Amendment No. 0004
18 August 2004

SUBJECT: Amendment No. 0004 to Specifications and Drawings for Construction of **Visitor Control Center / Main Gate, Minneapolis-St. Paul IAP-ARS, Minneapolis, Minnesota**, Solicitation No. W9128F 04 B 0015.

TYPE "G" MANHOLE
50-3741 F

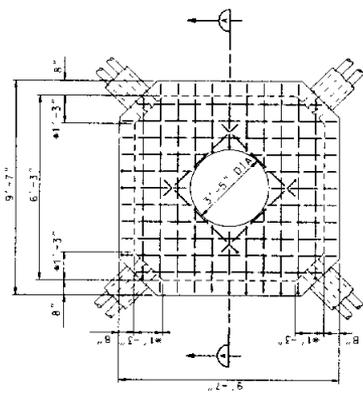
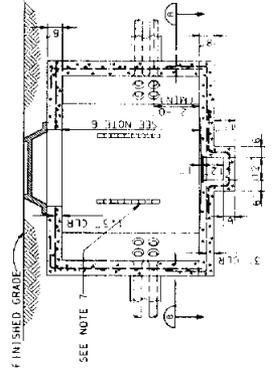
Type "G" Manhole Detail

TYPE "D" MANHOLE

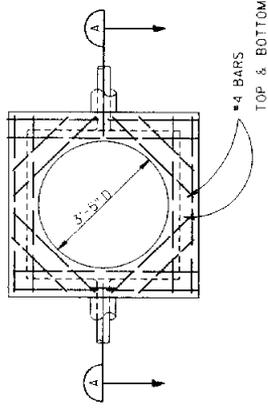
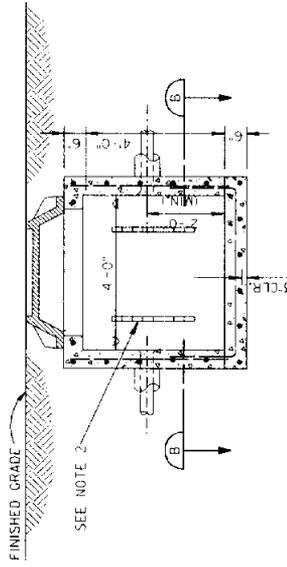
Type "D" Manhole Detail
